SUBJECT: MODE Over Pressure Valve (OPV)

Modular Oxygen Diving Equipment (MODE).

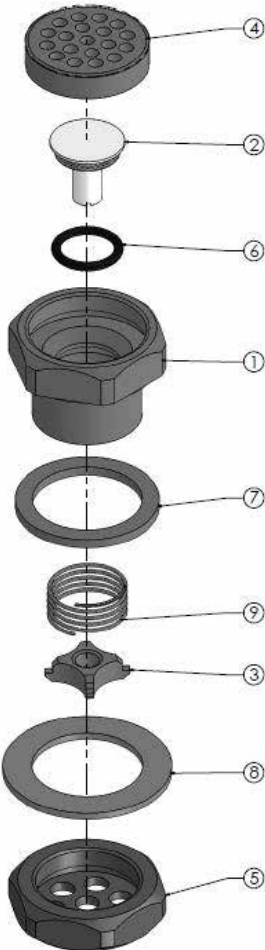
During extended UBA wet lay-up periods where repet dives will be made using the same ExtendAir cartridge, the alkaline environment inside of the breathing bag effects the structural integrity of the plastic OPV male threads. The chemical effect on the plastic male OPV threads has been so severe that some OPVs have cracked and broken.

NOTE: While Aqua Lung seeks to redesign the existing OPV from a compatible material, an aluminum OPV is currently available and is authorized and will be shipped at no cost to end users as an interim replacement.

1. Remove the existing OPV P/N 488190.
2. Ship to Aqua Lung America, Attn: Steve Reilly, 2340 Cousteau Ct Vista, CA 92081.
3. Install new aluminum OPV P/N 101200.
4. Conduct gas tightness test IAW MODE O&M before placing rig back into service.
